VALLEY AVE. - GREAT DIAMOND ISL.
83A-R-4

(RC) RESIDENCE ZONE
APPLICATION FOR PERMIT

AP Lot 42 Valley Avenue,
Great Diamond Island-I

LOT IN QUESTION - 83A-R-4

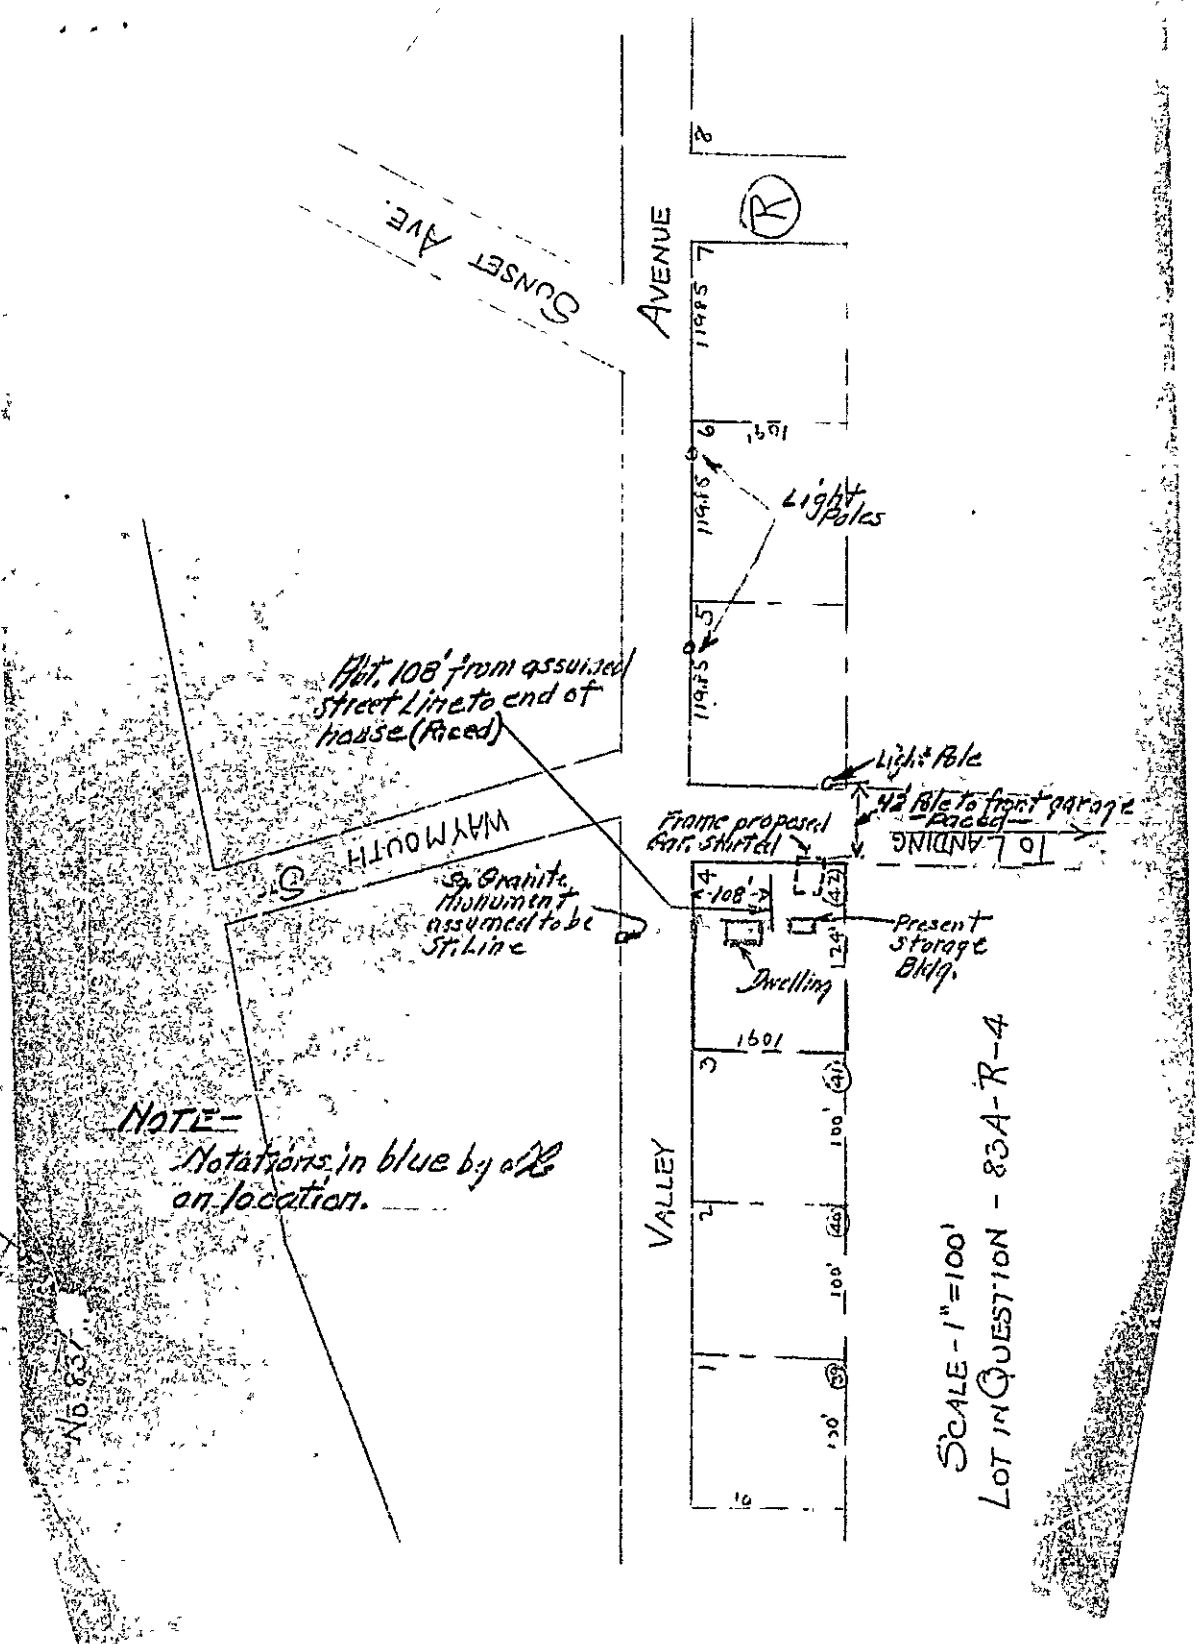
11-24-50. Work has been started, floor framed & boarded on one side only. Sills on only sides, floor joists laid on top sills.

Location could not be determined. The Murray's side of the street in deed is lot 42. Can not locate street line on lot. Murray has no idea as to his lot lines and could not locate any markers. See only information available on associated plan attached.

We are unable to issue a permit for construction of a garage 10' x 18' on the lot with your dwelling on Lot 42 Valley Avenue, Great Diamond Island, because the proposed location is closer than 20' to the line of the extension of Weymouth Street and closer to that street than the wall of your dwelling, contrary to Section 15A6 of the Zoning Ordinance. Although the corners of your lot are not marked on the ground and you say that you have no definite idea as to where street and lot lines are located, it appears quite likely that the proposed location of the building, as marked on the ground is not on your land at all and may even project into the continuation of Weymouth Street. Therefore, before anything definite can be determined, it is necessary that the location of the lines of Valley Avenue and Weymouth Street and the other two lines of your lot be located; but even if this is done, we have no authority to issue a permit for a location of the building closer than 20' to the wall of your dwelling to Weymouth Street. For your information, data shown on plans on file at the Assessors' Department indicate that Lot #42 runs a distance of 124' along Valley Avenue and 109' along the extension of Weymouth Street.

It is unlawful to start any work on this building until matters have been straightened out so that a building permit can be issued and the permit is in your possession.

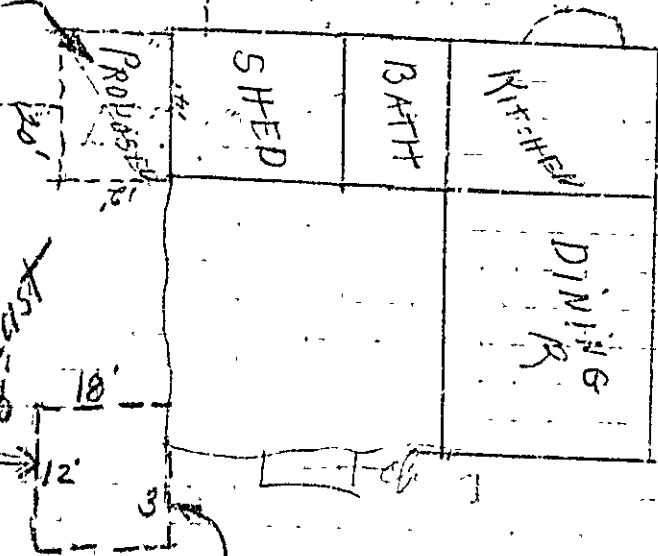
addition as applied
for Oct. 23rd and
not to be done

10-26-50. Likely addition
is gone over with Mr. Merrill
on location. Permit to be
applied for later.
